MARTIN
COAL GASIFICATION
COMBINED CYCLE
PROJECT

SITE CERTIFICATION APPLICATION
SUFFICIENCY RESPONSES

FLORIDA POWER & LIGHT COMPANY'S
NOTICE OF FILING RESPONSES TO
SUFFICIENCY QUESTIONS OF
THE DEPARTMENT OF ENVIRONMENTAL REGULATION
AND THE
SOUTH FLORIDA WATER MANAGEMENT DISTRICT

Re: FPL Martin Coal Gasification/Combined Cycle Project
Power Plant Site Certification Application PA 89-27
DOAH Case No. 90-259

EXHIBIT DER-59

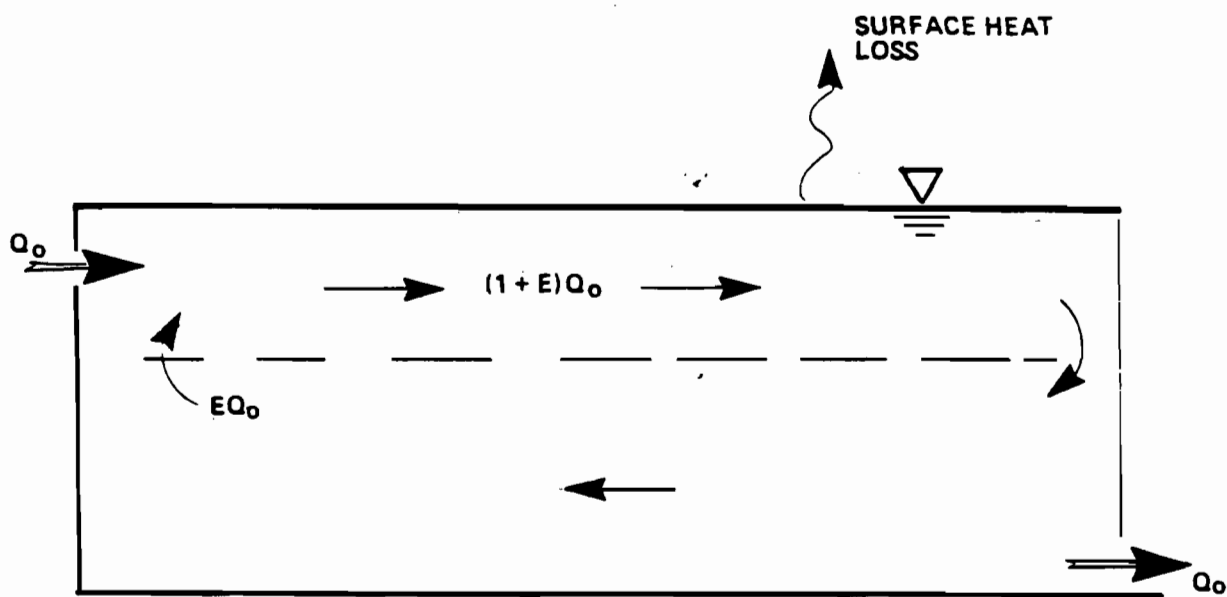
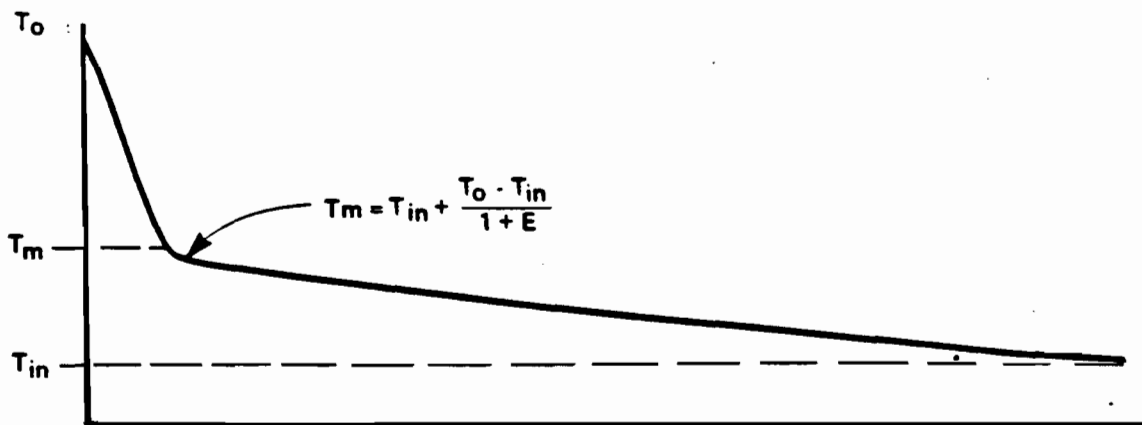
59. A more detailed analysis should be provided for the cooling pond thermal analysis of Section 3.5.1. This analysis should clearly show all model input and output variables and provide justification for the input values used.
